Product  
Newsletter

September 1997

## Change in RR-II Valve Bank

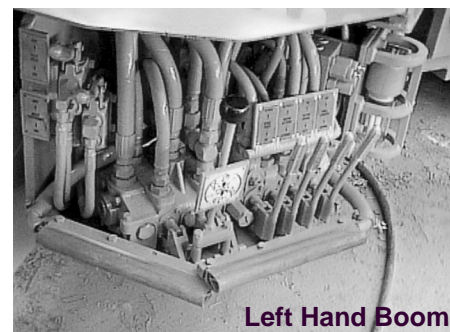
The original design of the RR-II Dual Boom Roof Drill Offset Boom utilized a Commercial valve bank for operation of the feed and rotation functions while a Gresen valve bank was used for the canopy, foot, extend and swing functions.

Although the Gresen valve bank performed adequately, the relatively small valve spools and control handle assemblies associated with this valve bank were felt to be a maintenance problem by some customers.

To eliminate these spool and handle assembly problems we decided to replace the Gresen valve bank with a Commercial valve bank which was integrated

with the existing Commercial valve bank that controlled the drill feed and rotation.

Besides eliminating the spool and handle maintenance problems, this change also eliminated some of the hosing required in this area of the machine.

This change can be made to existing RR-II machines in the field. If you would like additional information please contact your local Fletcher sales or service representative or our Service Department (304) 525-7811
